New Folder Name LIGO Beam Tube Cover

Revision comments on proposed cover modifications
T950020

LIGO-T950020-00-B

Subj: **LIGO Beam Tube Cover Revision**

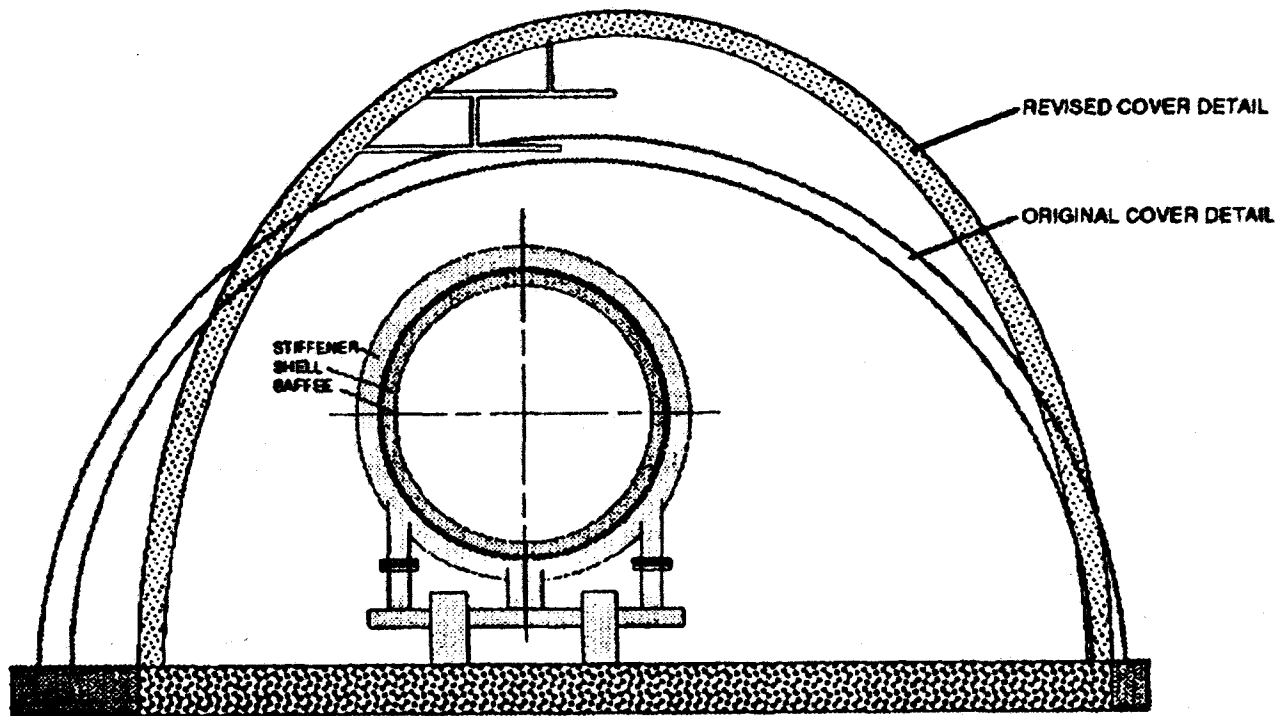
WELD SHELTER-

I agree with you. The weld shelter will have to be centered and this will create additional loading on the weak side rail. We will check this when a foundation loading is known.

2.Included above. I have attached a general sketch of the weld shelter with some dimensions.

COVER COMPARISON

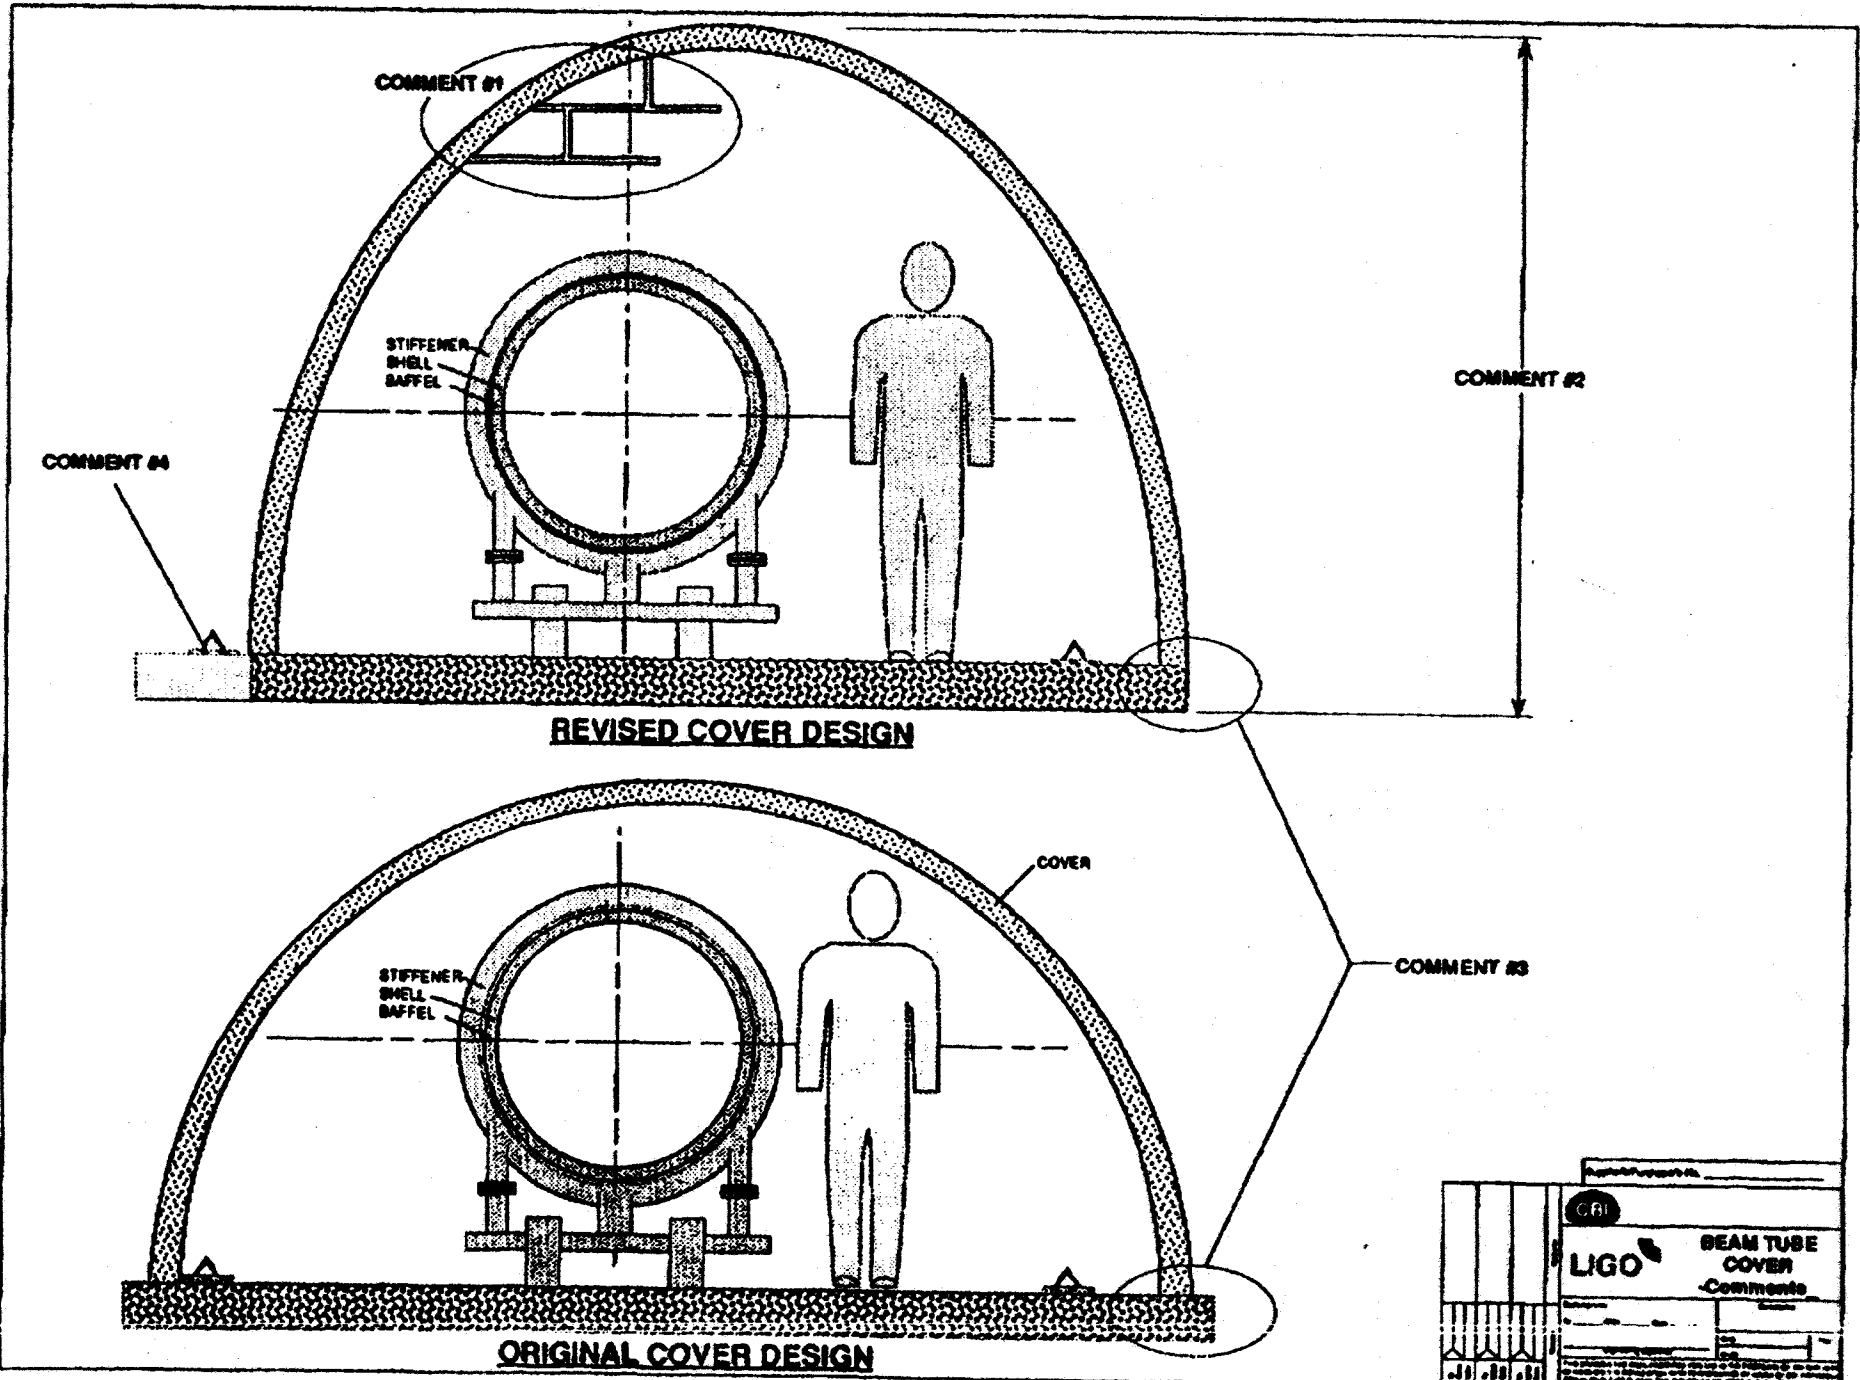
I am guessing that the detail above the beam tube assembly noted in the R.M.Parsons sketches are wire-ways and/or cable trays. This presents a problem with the use of a direct attachment antenna proposed by CBI. The positioning of equipment above the beam tube is not the thing to do. We are walking the edge of GPS technology with our current plan and cannot afford the additional effects of secondary reference measurements. Metal trays could also interfere with GPS signals and this should be checked to assure there is no possible problems.

I see two problems with the increased height of the beam tube cover:

- a) The additional height will effect multipath error for GPS. We may be able to deal with this, but it should be considered additional concern. The best method of avoiding this altogether is to use a material that would allow reception of GPS signals. This means performing successful tests on acceptable cover materials.
- b) The increased height of the cover will lengthen the antenna reference and increase error. I agree with you that this will probably be geometrically insignificant but will increase data gathering time periods and require some additional support details to compensate for weight and rigidity.

The overlap of the foundation pad beyond the arch was somewhat significant to the areas where direct access to the beam tube was not possible. It also played a part in Jerry's idea of installing

reference points outside the cover if direct tube mounting of the antenna was not possible or approved. The detail in RMP's sketch shows no overhang and we should ask if this is the final detail.

The loading on the rail system will increase for the weak side rail. If we can find what loading RMP is working with, I can check out the support plate sizes under the rail and see if it presents a problem.
